RE: Request for modification of fresh air ventilation requirements, exiting, toilet count at 16786 E. Iliff, Colorado Islamic Center

Colorado Islamic Center - Masjid Salaam - Occupany Change

Project: **Colorado Islamic Center**
Address: **16786 E Iliff Ave**
Occupancy Group: **A-3**
Construction Type: **UBC V-N**
RSN: **912192**
Permit: **2014-860667-LT**

1 Mechanical - New
3/16" = 1'-0"

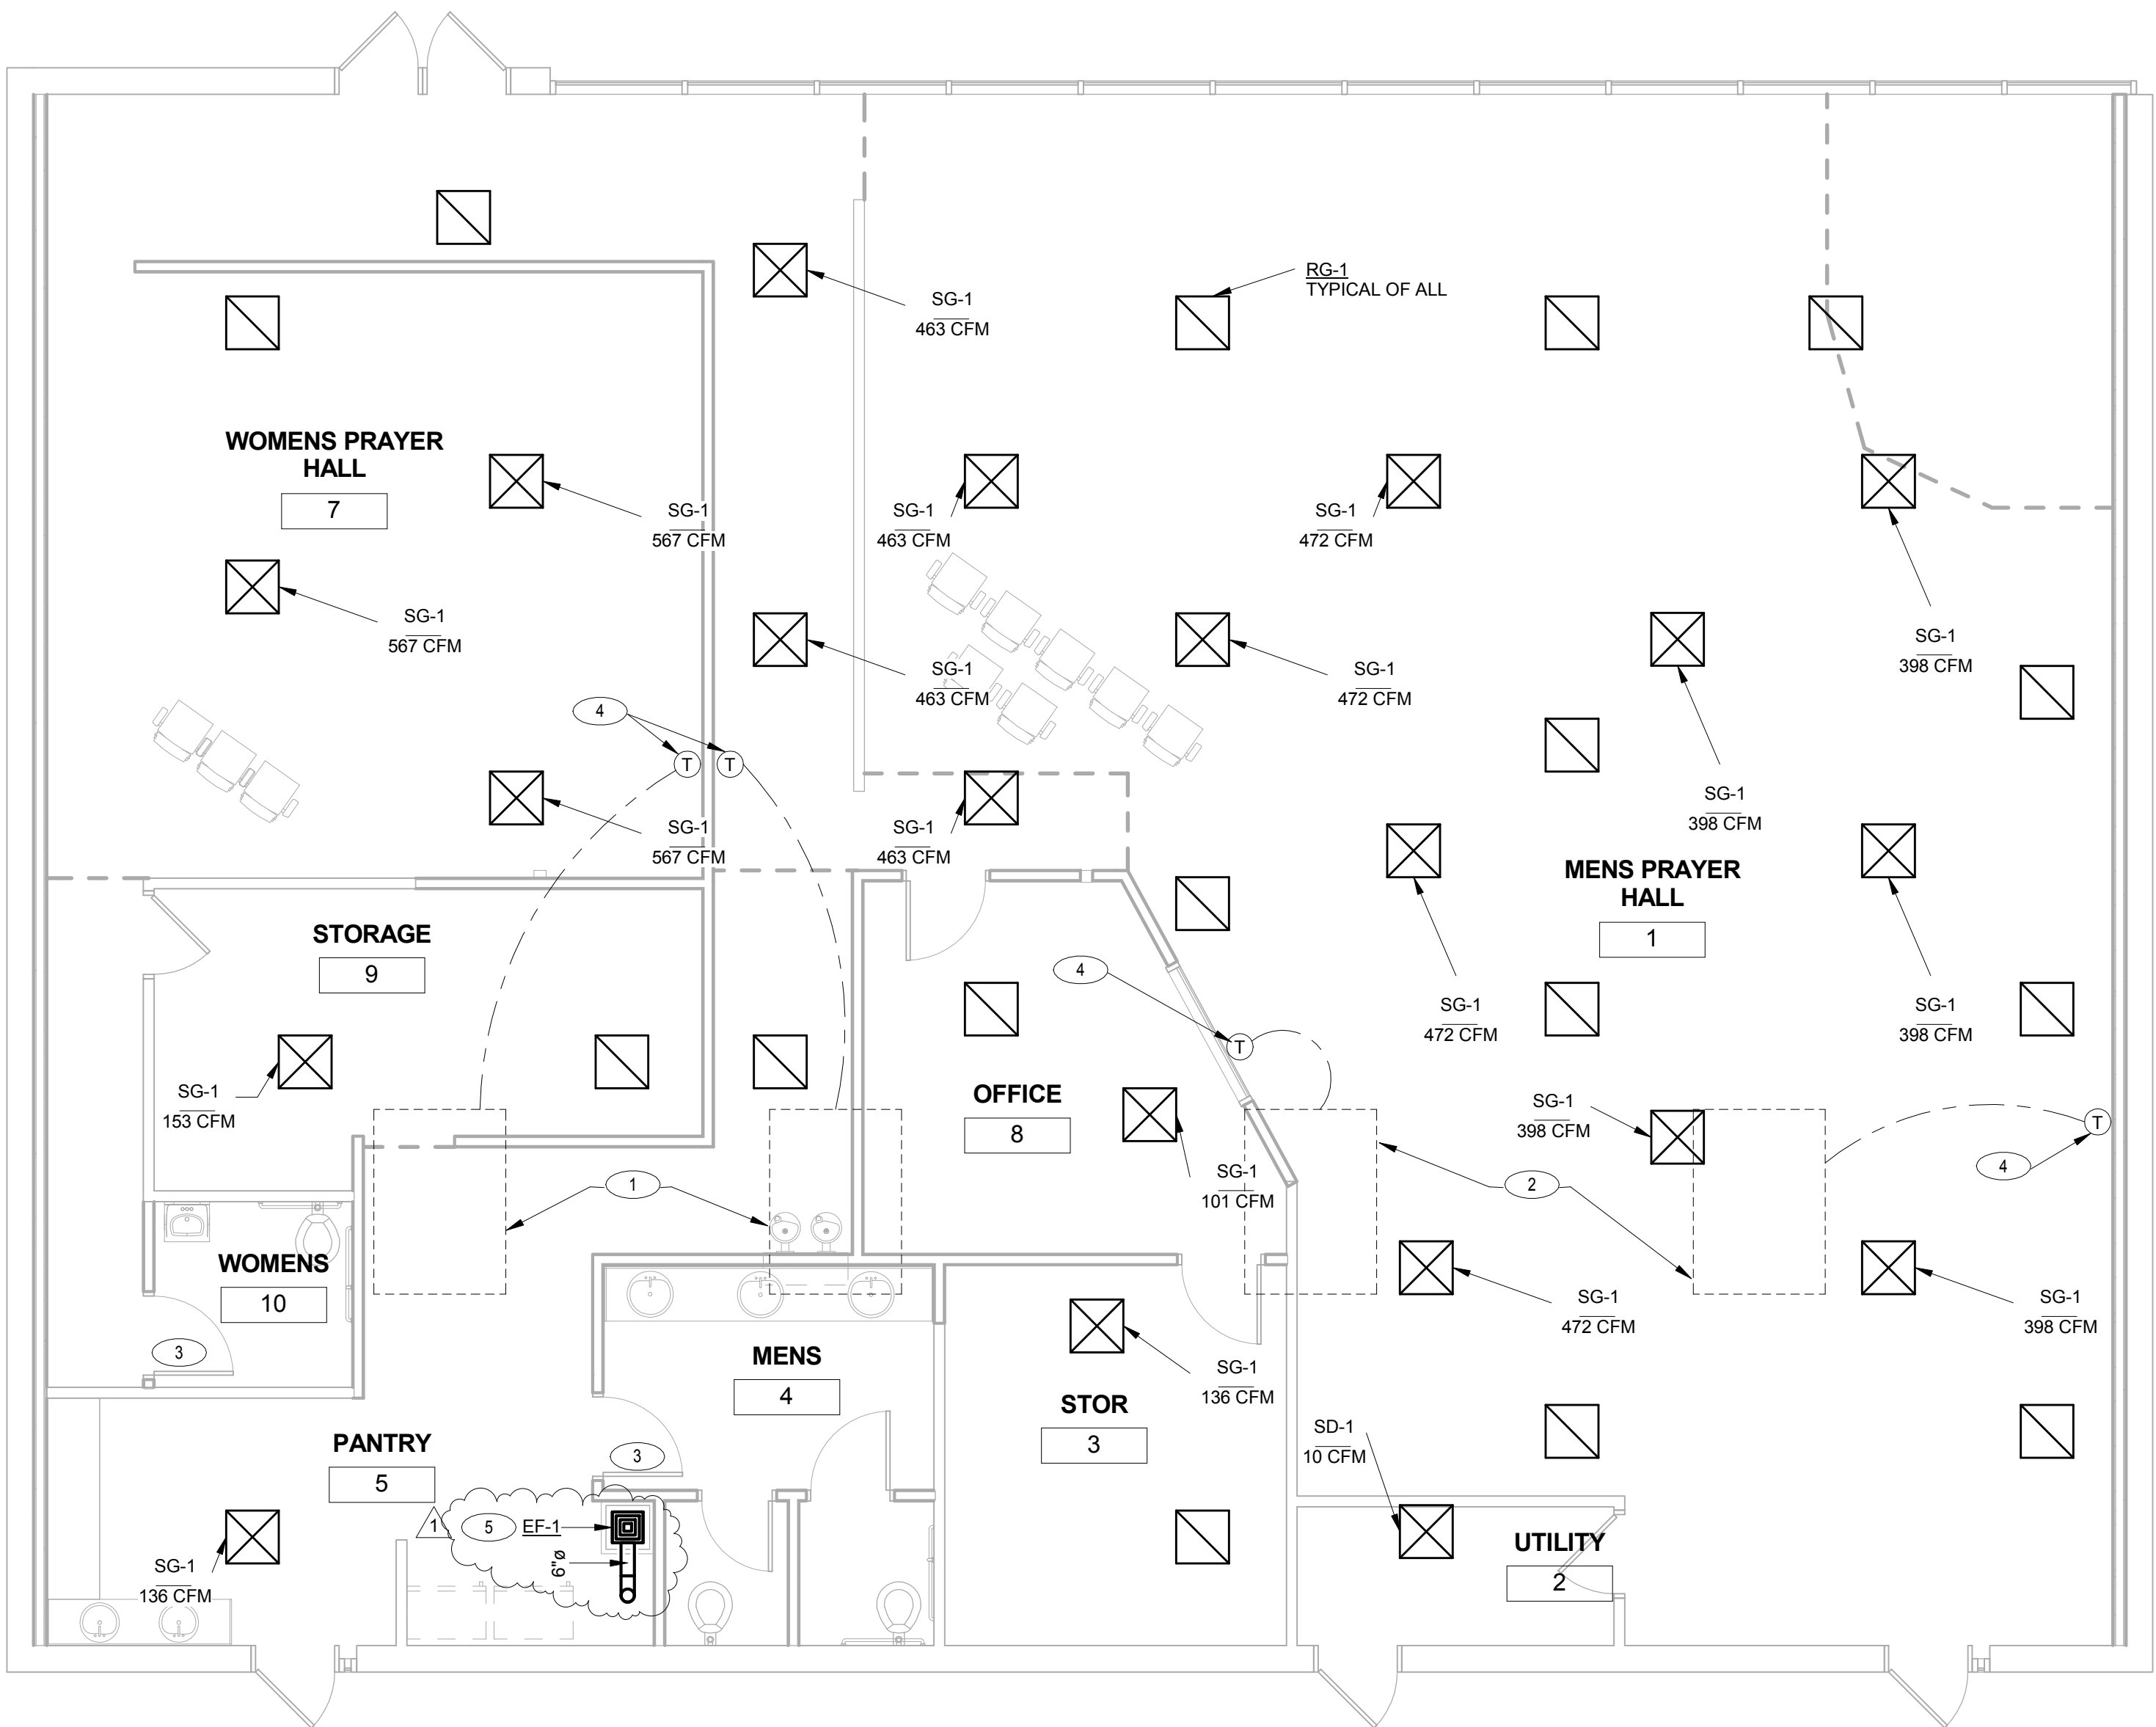
Provide existing RTU's name plate information to structural inspector for verification that new units weigh less than existing units. If new units weigh more than the existing RTU's, engineering may be required.

1 ELECTRICAL PLAN
1/4" = 1'-0"

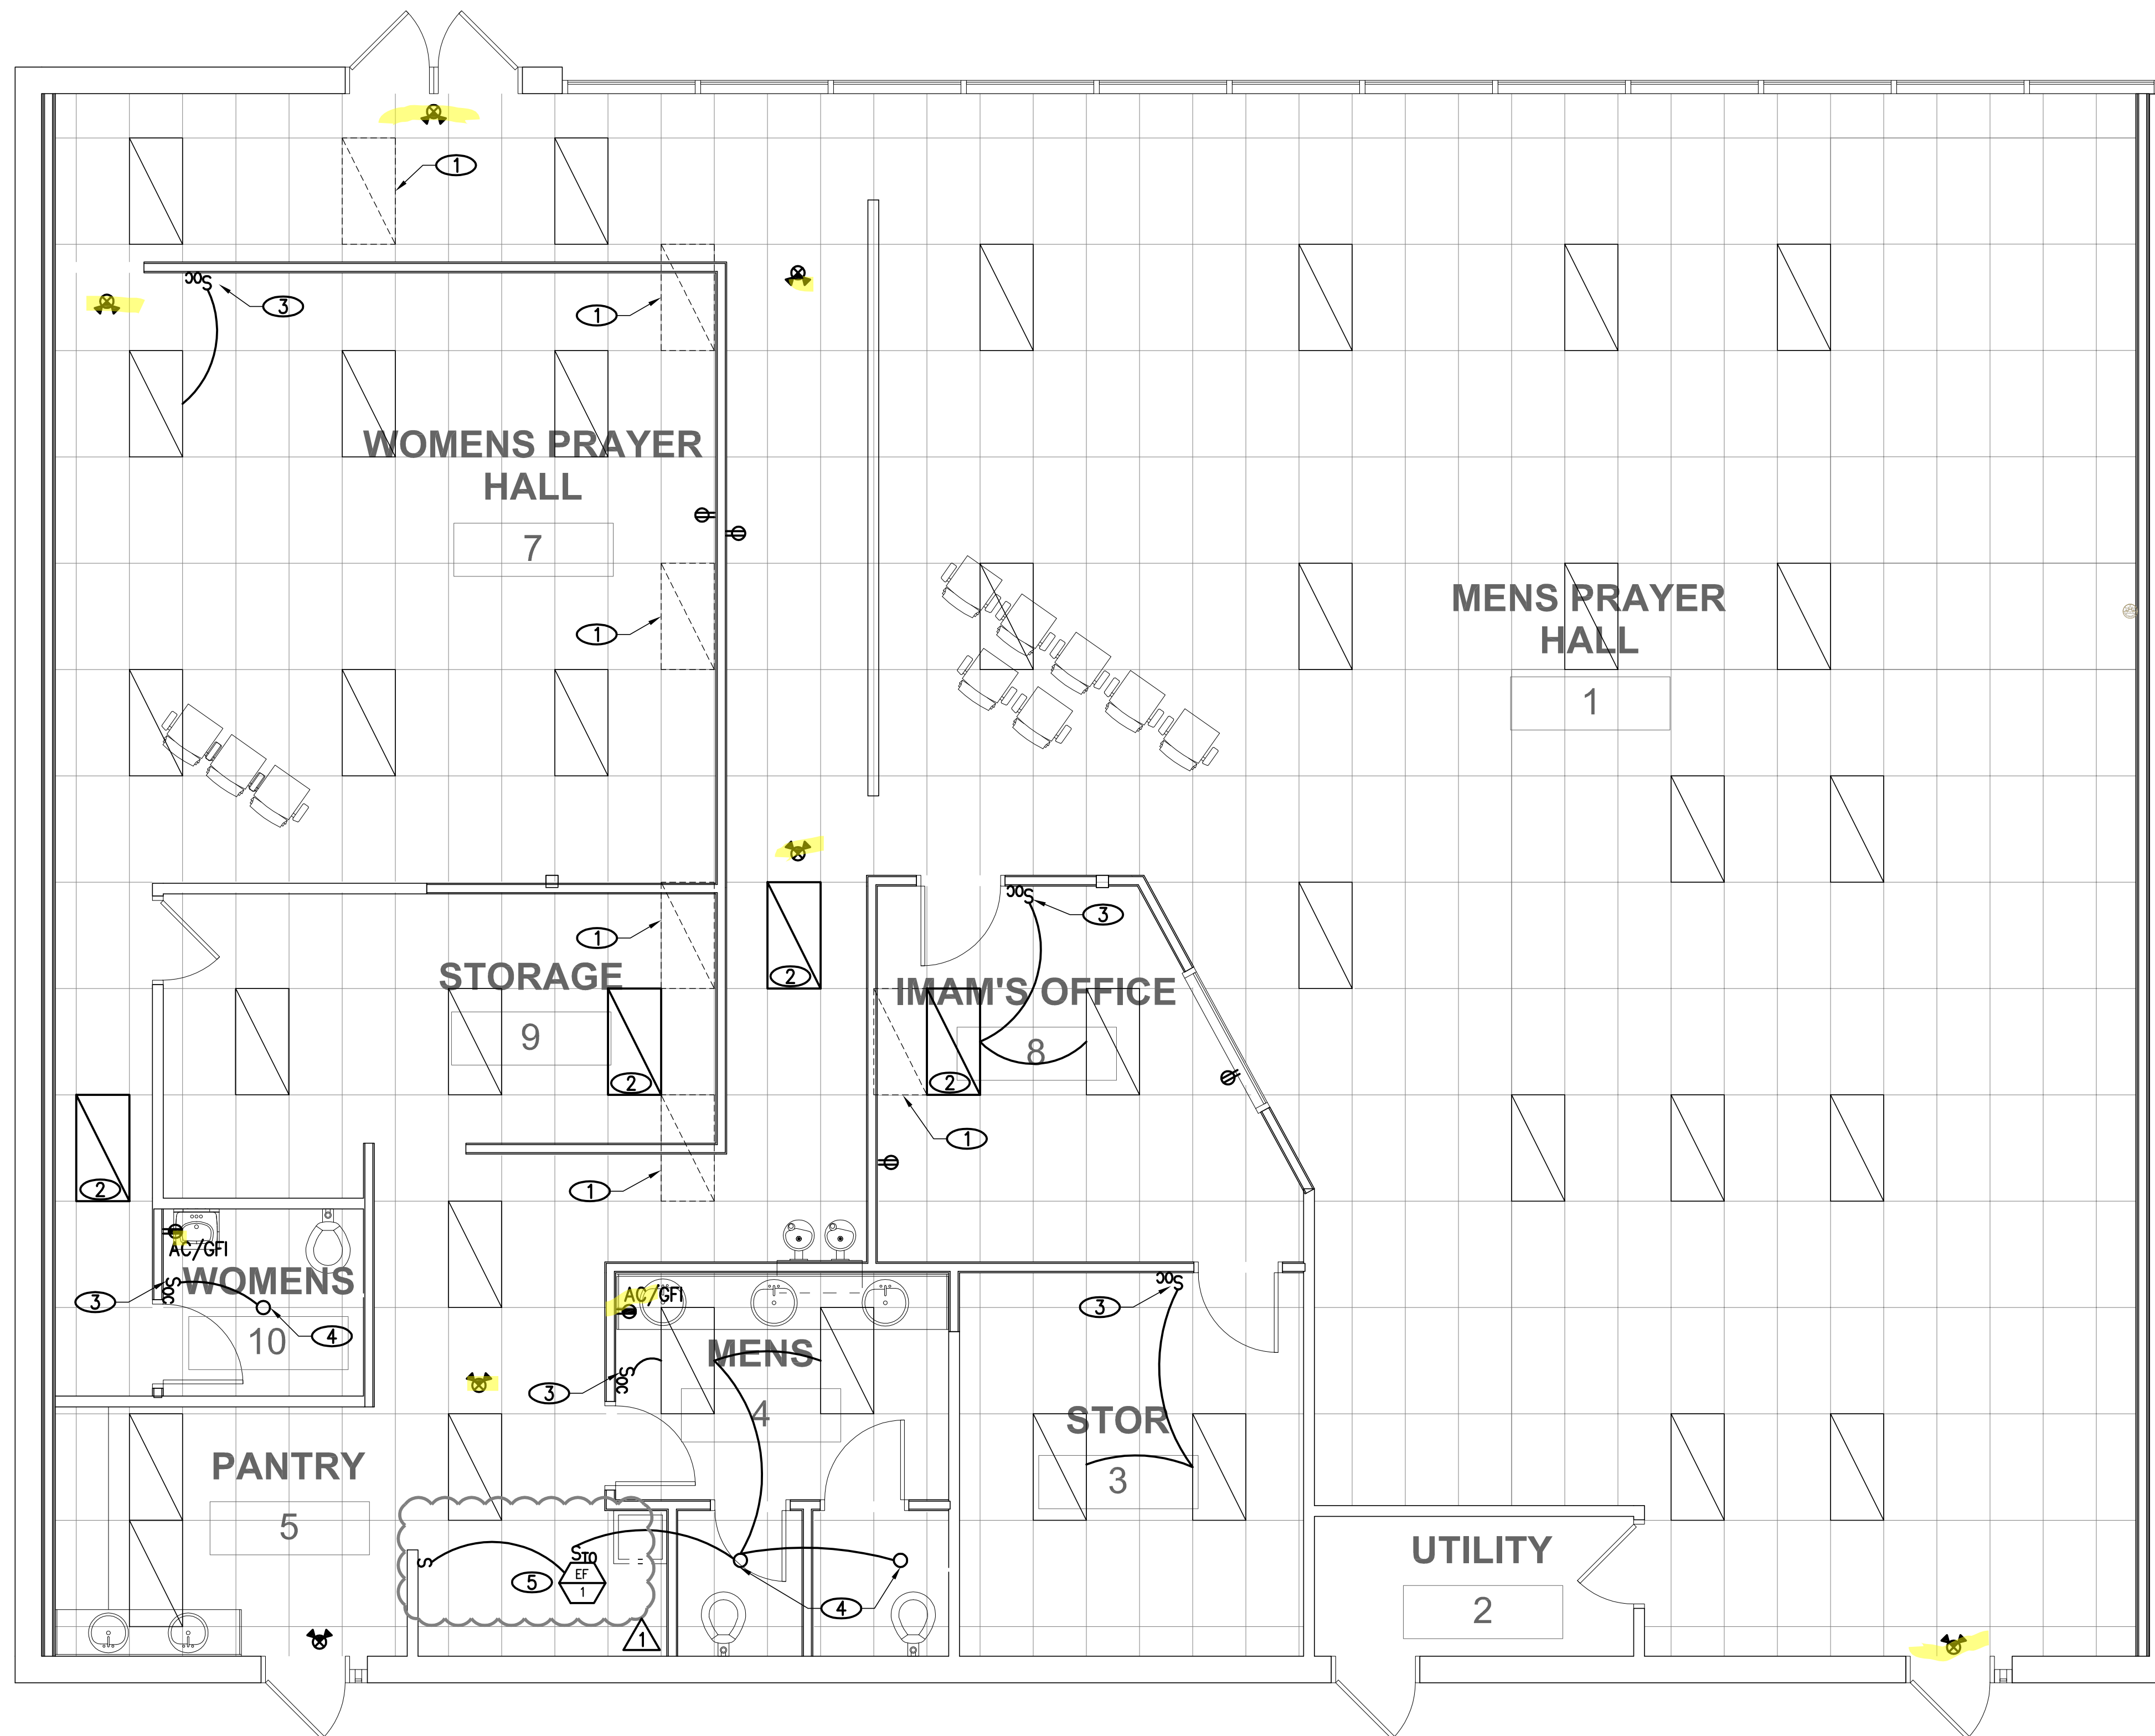
Provide emergency illumination equipment that complies with 2014 NEC 700.12 (F) or 2014 NEC 700.

Install electrical connections per 2014 NEC 110.14, identify disconnects per 2014 NEC 110.22 and provide working space around electrical equipment per 2014 NEC 110.26.

Provide a grounded electrode system bonded to the service equipment enclosure, grounded conductors, and grounded electrode conductors per 2014 NEC 250.50 and 250.104.
